RE: Telesto/LRM comments on DRMS AM-4 application – Home Office Mine, Permit M1977-439

This letter is in response to the specific comments and questions in your letter of February 25, 2022, documenting comments on behalf of Loveland Ready-Mix Concrete, Inc. (LRM) on Exhibit G of Martin Marietta's 112c Permit Amendment Application (AM4) for the Home Office Mine, submitted on December 23, 2021, File No. M-1977-439. Below are your comments followed by Martin Marietta's responses.

EXHIBIT G: WATER INFORMATION

TAFT HOME OFFICE AMENDMENT EXHIBIT G

G-3

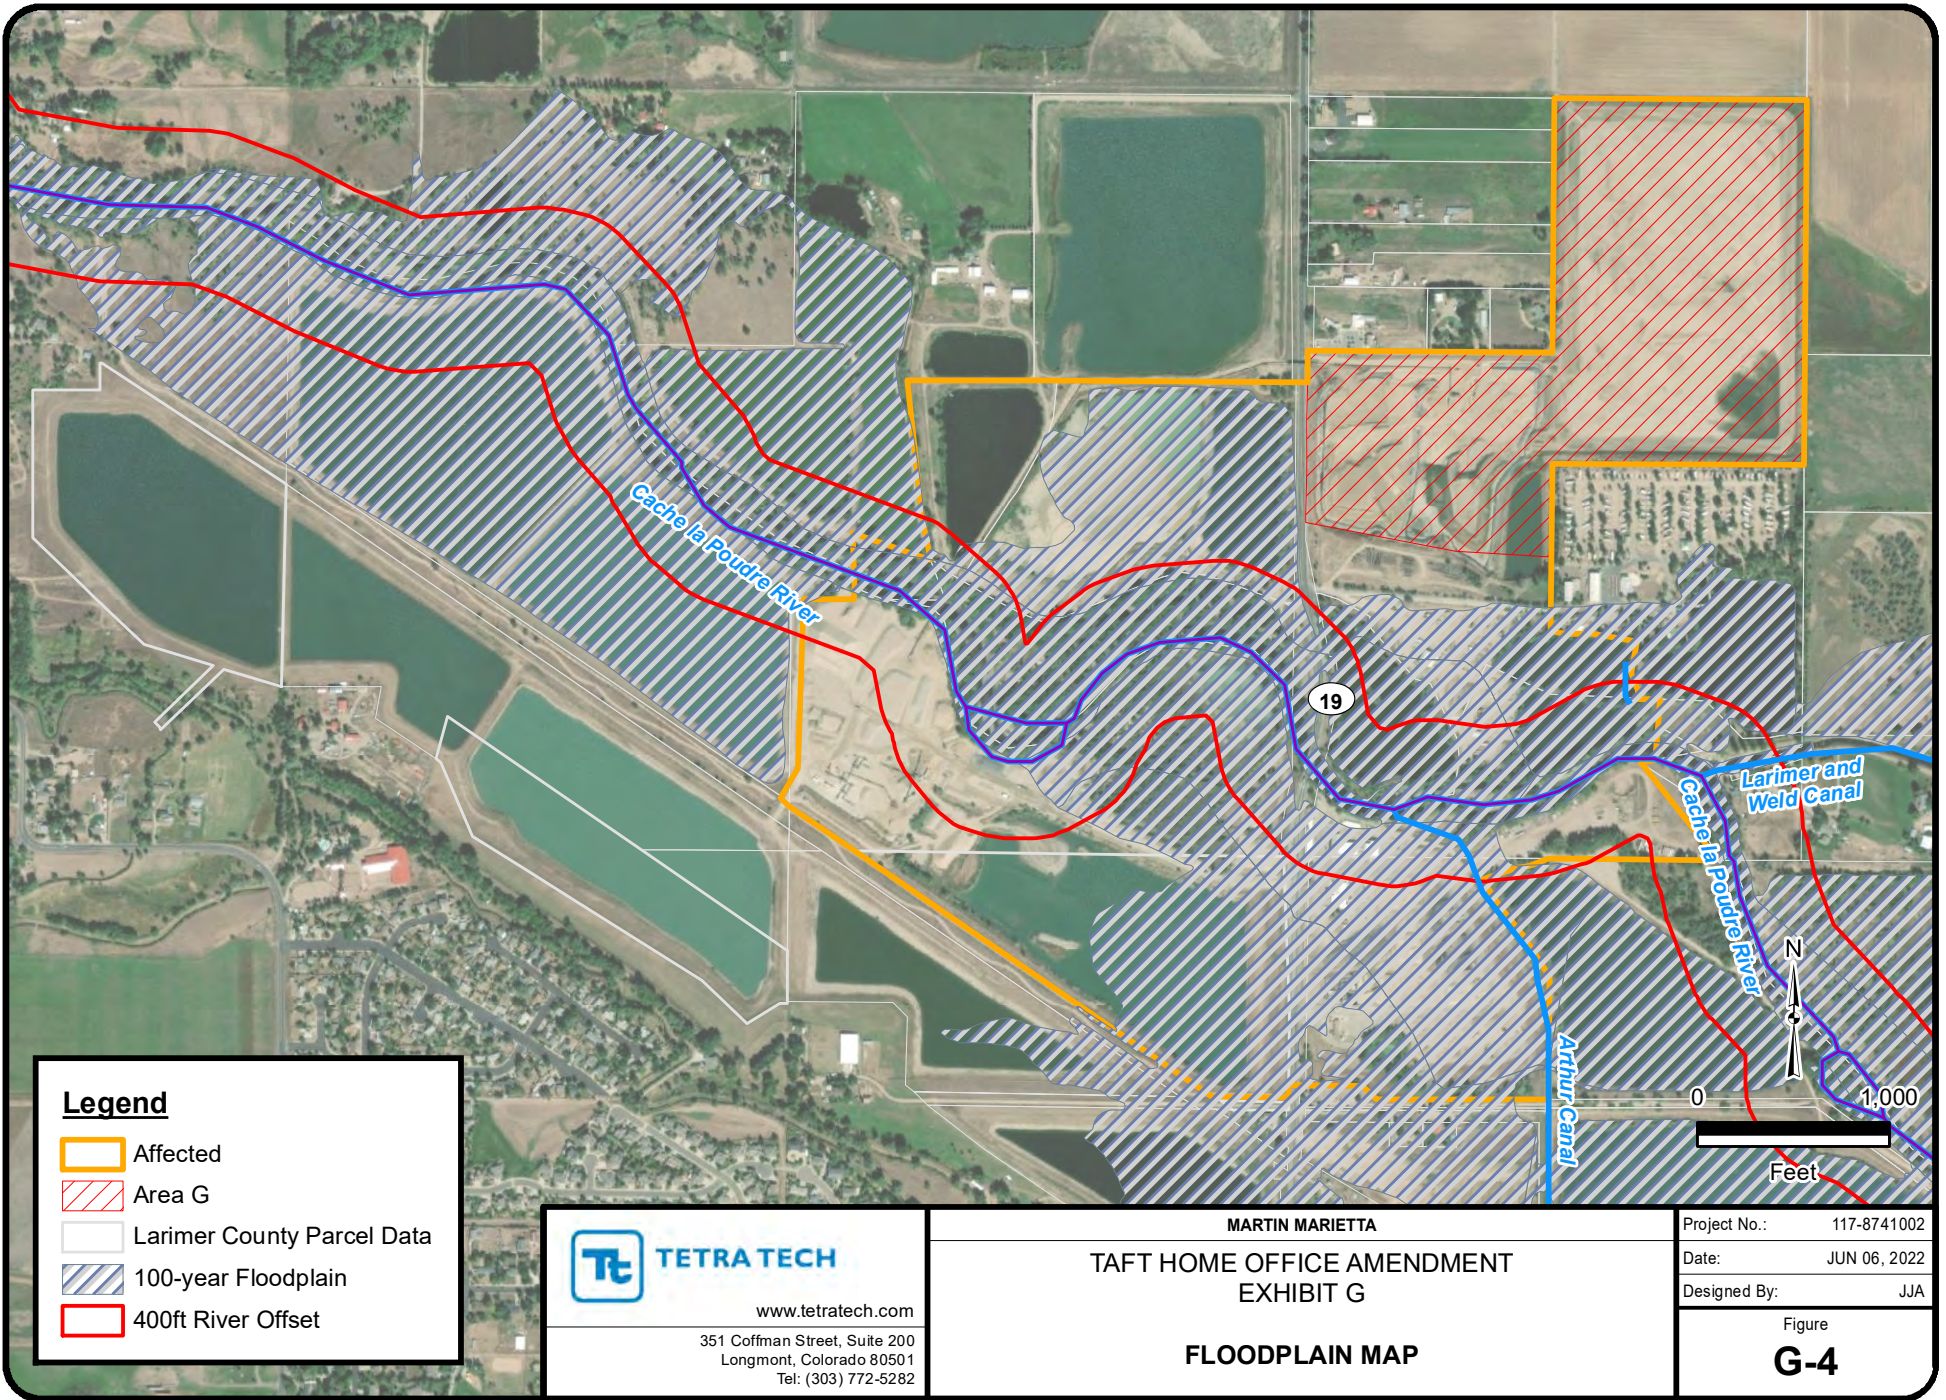
The first paragraph describes monitoring wells installed in 2005. Which wells are these? Where are they located? Where are the data? These would be very useful in helping LRM understand potential impacts. Please provide a plan view map of their locations and historical data.

Groundwater elevations shown in Charts 1, 2 and 3 are helpful when combined with the location map to help understand groundwater gradients but do little to explain how close the groundwater is to ground surface, and what the potential impacts could be to landowners. Please provide depth to water information for these wells.

Numerous monitoring wells were installed, generally beginning in 2001 through 2021. Monitoring well data is available beginning in 2007 for the nearby wells referred to as “Stegner Cornfield aka MM Near KOA”. Monitoring well data is available beginning in 2004 for the nearby wells referred to as “Koonce” and “Slatten”. Records from Lafarge indicate these wells were installed in 2001. Figure G-3 shows the locations of the Koonce, Slatten, and Stegner Cornfield aka MM Near KOA wells.

Depth to water information for wells discussed in Exhibit G has been added to Exhibit G. Figure G-3 shows the locations of wells discussed in Exhibit G.

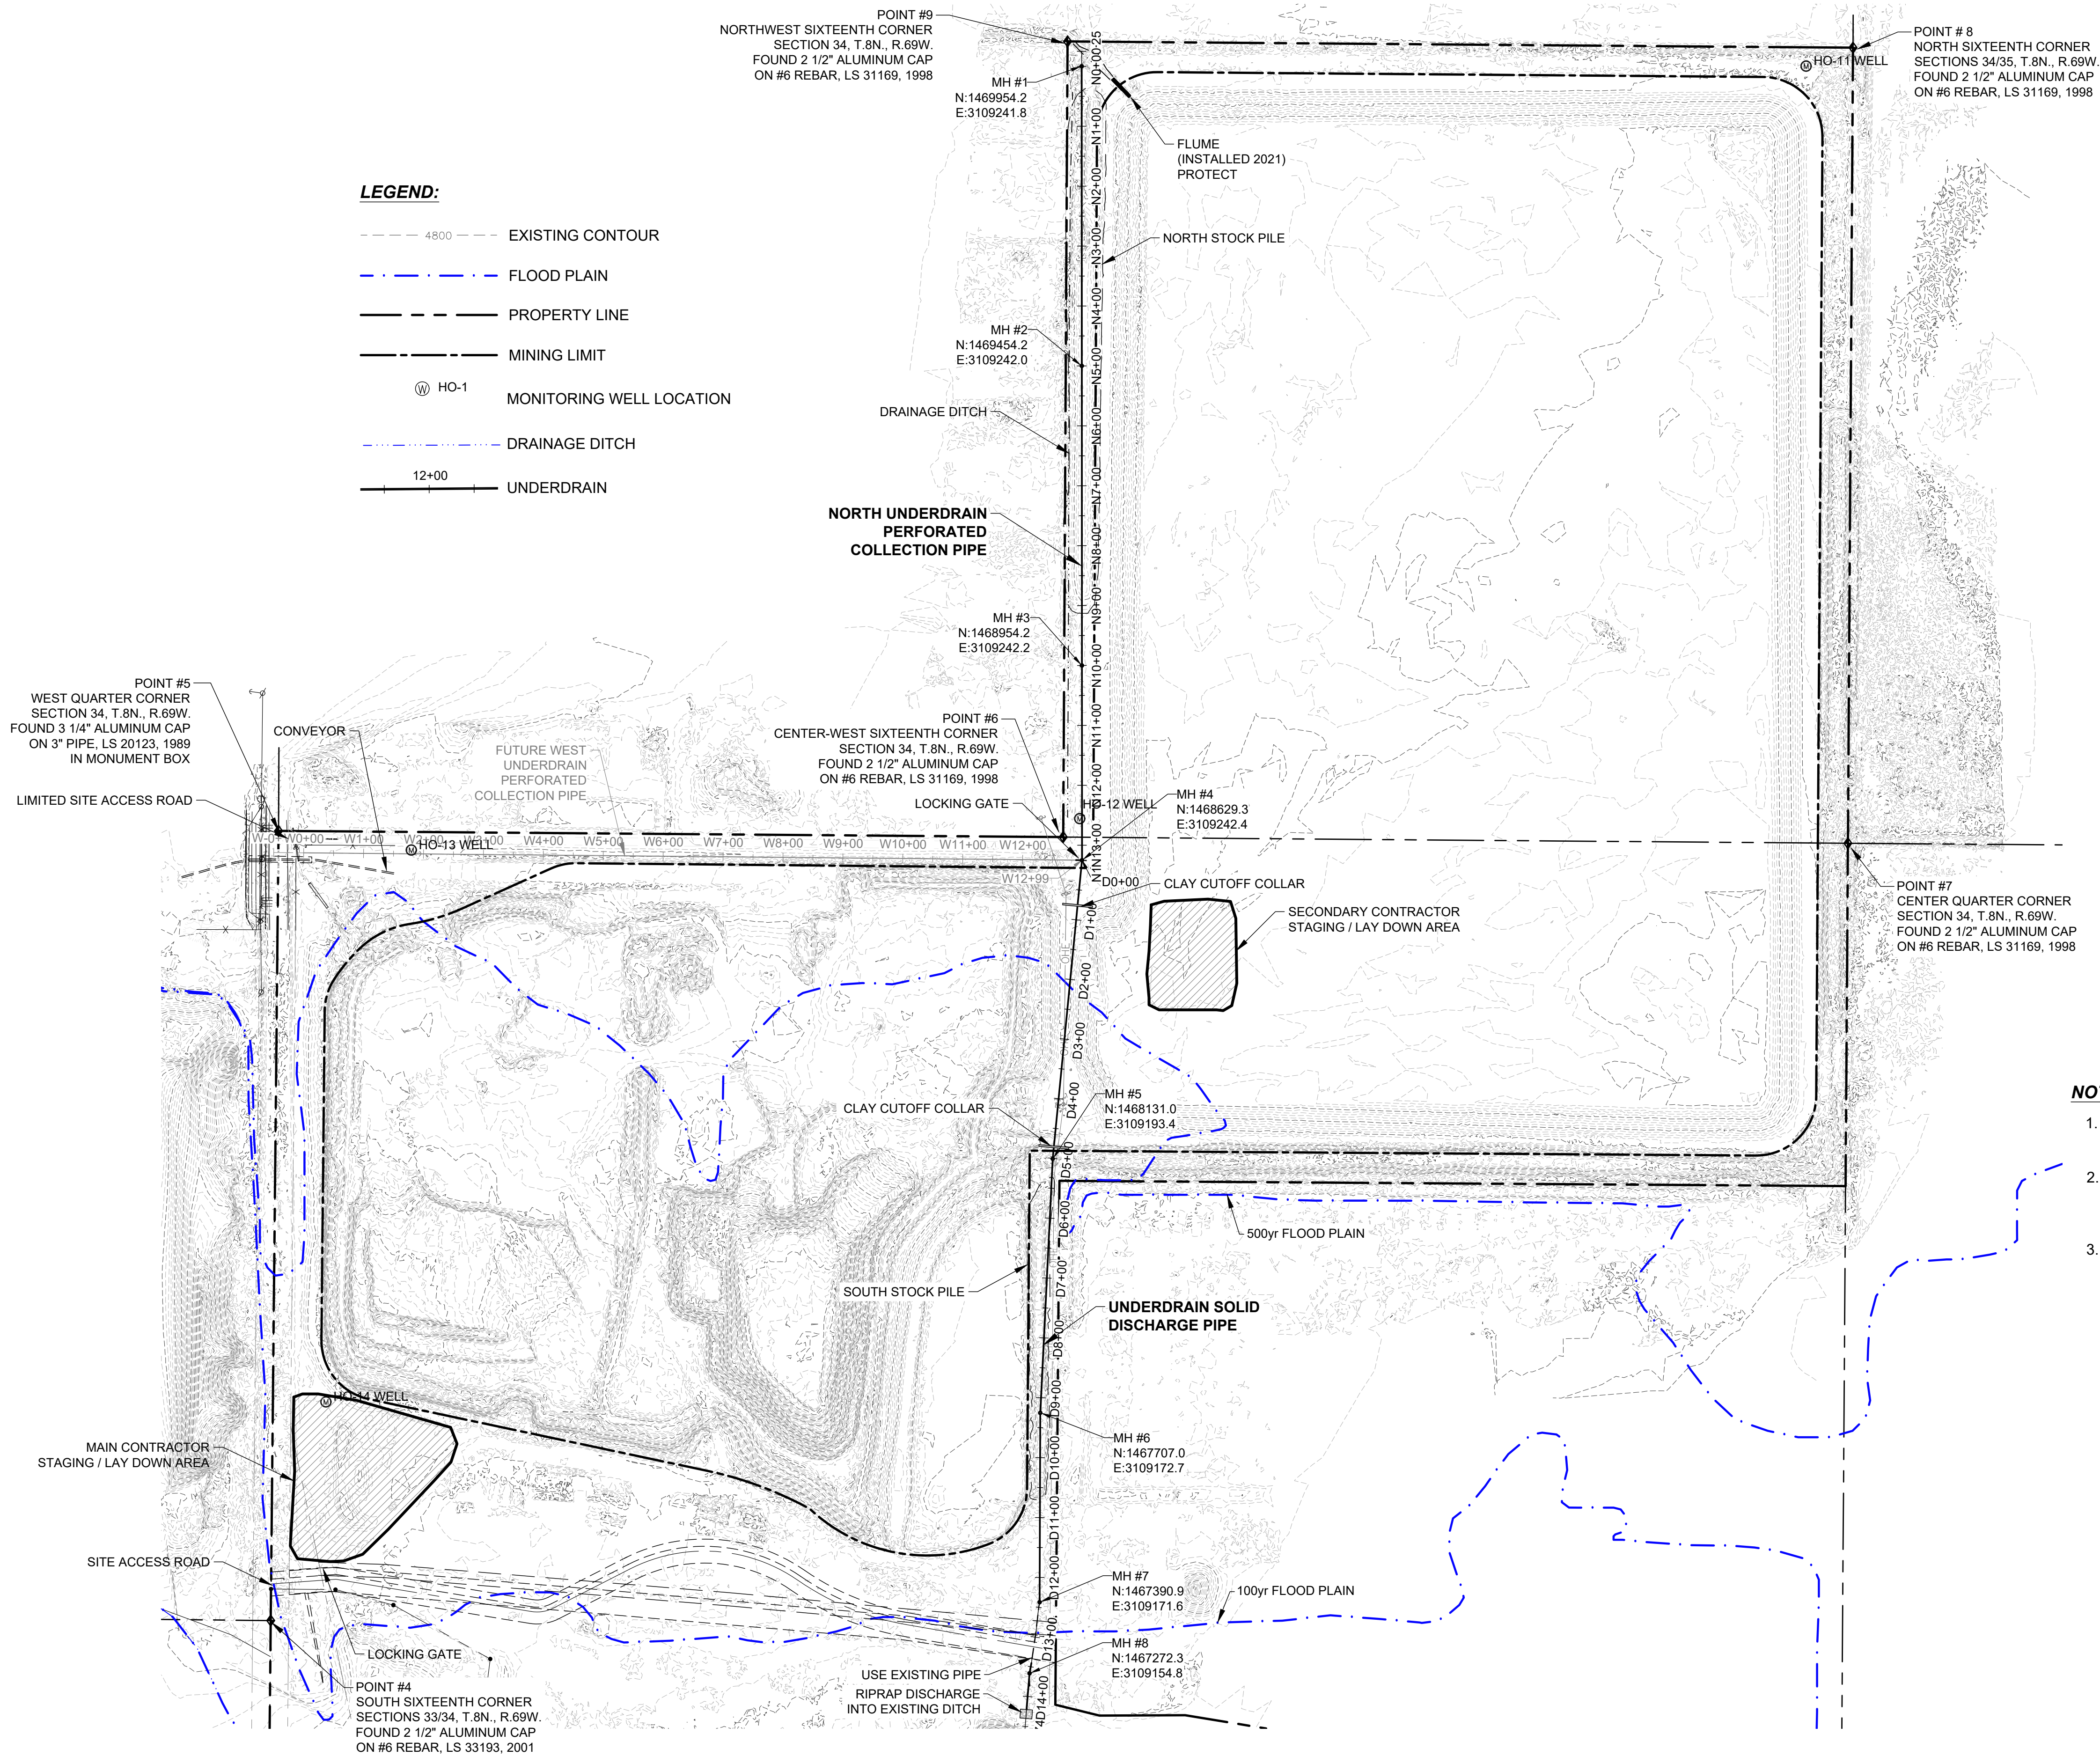
It is not clear whether the "underdrain" shown in Figure F-3 is the "perimeter drain," or if another drain is planned. Please provide design details (or as-built drawings) for the perimeter drain. Include:

- Plan and profile along the proposed alignment
- An effective hydraulic conductivity analysis
- Hydraulic analysis

These should show the combination of the perimeter drain and liner is equivalent to the pre-mining condition in terms of its carrying capacity. Also, include the area north of the Phase 1 pit in this analysis to show the potential impact to LRM property.

The plan view on Figure F3 labels an "underdrain" perforated pipe skirting the west side of the Phase 1 pit, passing between Phases 1 and 2, turning solid and emptying into the recharge pond on the southeast side of Phase 2. The perforated drainpipe and trench bottom are roughly 5.4 and 6.4 feet, respectively, below the top of the liner, which is essentially at natural grade. Based on water levels taken on LRM's property, the bottom of the drain might intersect the top of the natural water table, and thus, it appears the drains are not planned deep enough. It is our

experience that French drains that extend over at least half of the saturated thickness are necessary to efficiently move groundwater around impermeable structures. Please provide an analysis regarding the drain sizing, depth, and location (horizontal and vertical) that efficiently and effectively moves groundwater around the lined pit on all sides and maintains the hydrologic balance. Related, provide methods and infrastructure design to maintain (e.g., cleanouts) and ensure the drain has a long life.

The underdrain and the perimeter drain are the same drain. For clarity, the nomenclature used for the drain will be "underdrain" rather than perimeter and/or underdrain. This language has been clarified in Exhibit G. The underdrain that has already been installed will not be changed. However, upon completion of mining in Area G-II, an additional section of underdrain will be installed. This section of drain is located along the north side of Area G-II and will connect to the existing underdrain at the northeast corner of Area G-II. Construction drawings prepared by Deere & Ault, A Schnabel Engineering Company are provided in Exhibit G, Attachment 2. In addition, Deere & Ault, A Schnabel Engineering Company provided hydraulic analysis calculations which have also been included in Exhibit G, Attachment 2.

The discharge elevation of the underdrain was installed at 5011.87, which is at or below the historic water level. The underdrain was installed at a slope ranging from approximately 0.16-0.49 % and is therefore located at the maximum feasible depth to be able to convey groundwater along the historic groundwater flow pattern. The upstream-most invert of the drain is approximately 5 feet below ground surface. Construction plans with as-constructed information prepared by Deere & Ault, A Schnabel Engineering Company are provided in Exhibit G, Attachment 2.
